MISCELLANEOUS PAPER GL-86-23

# REVIEW OF RIGID PAVEMENT DESIGN FOR CONCRETE FLOOR SLABS ON GRADE

August 1986  
Final Report

Figure 1. Design curves for concrete floor slabs by design index

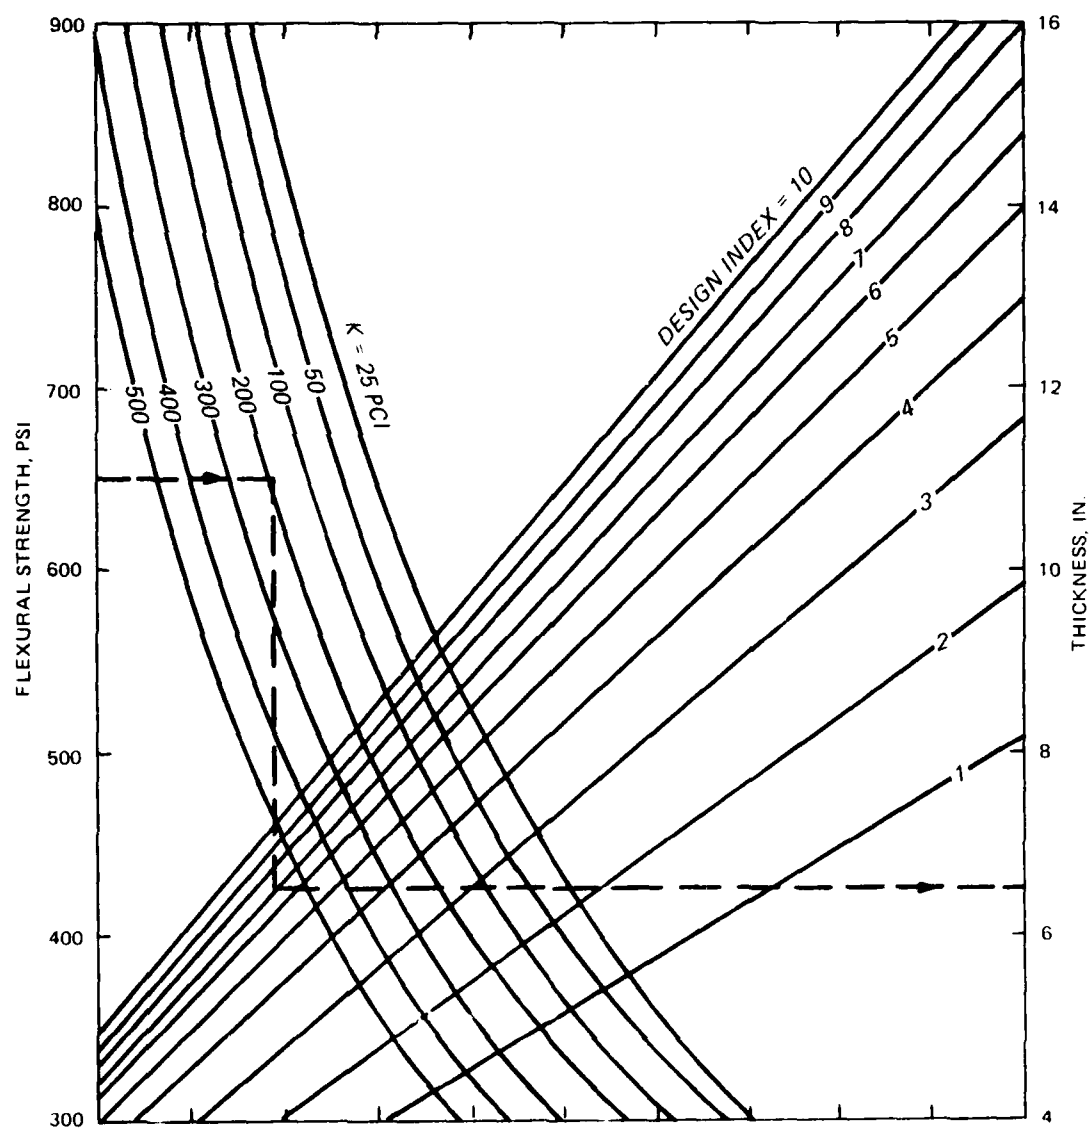
13. The design curves in Figures 1 and 2 of TM 5-809-12 (Headquarters, Department of the Army 1977) are hereby revised by substituting those shown in Figures 1 and 2. An explanation of each figure is as follows:

- a. Figure 1 is the design chart for vehicular parking areas. The design indexes shown are for rigid pavement roads and streets as defined in TM 5-822-2 (Headquarters, Department of the Army, in preparation). The original floor slab design indexes 1 to 4, developed from four typical small forklift traffic mixes, are now represented by design indexes 4, 5, 7, and 8, respectively.
- b. Figure 2 is the design chart for large forklifts having axle loads between 25 and 120 kips. For pavements designed to carry these large loads, vehicles having axle loads less than 25 kips (trucks, cars, buses, and small forklifts) do not significantly affect the required slab thickness. They are therefore ignored for the purpose of thickness determination.

Figure 3. Design thickness for reinforced floor slabs (from TM 5-822-6)

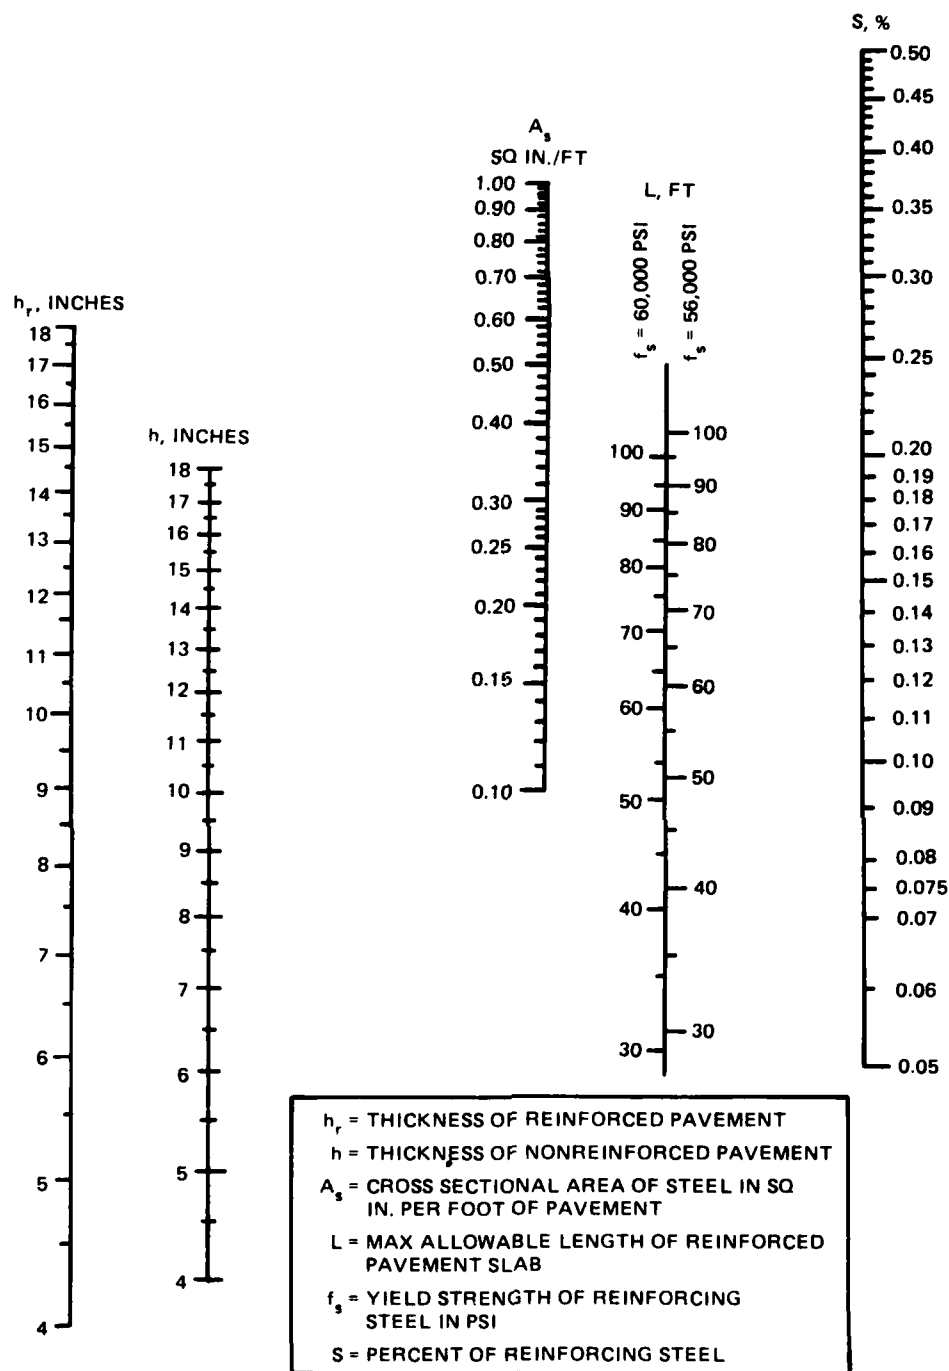
16. For reinforced slabs, thickness reductions for reinforcing steel are now allowed for as little as 0.05 percent steel. The same maximum of 0.5 percent reinforcing steel for thickness reduction is retained. This change is implemented by incorporating the nomograph of the March 1984 draft of TM 5-822-6, (Headquarters, Department of the Army, in preparation). This nomograph is shown in Figure 3.

Figure 4. Design curves for steel-fiber-reinforced concrete floor slabs by design index

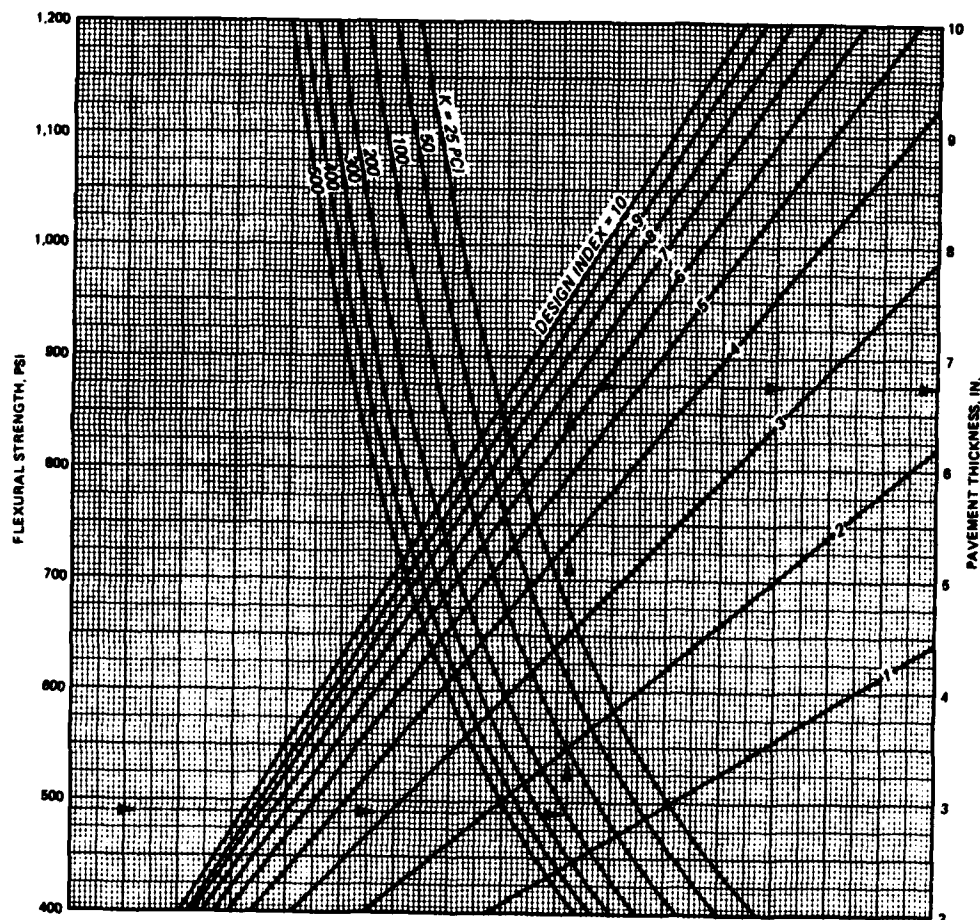
20. The thickness design curves for use with steel-fiber-reinforced concrete slabs are shown in Figures 4 and 5. Deflections are determined from Figure 6 and checked against Figure 7. Note that axle loads less than 25 kips do not produce deflections in excess of those allowed by Figure 6, and therefore do not require a deflection check.
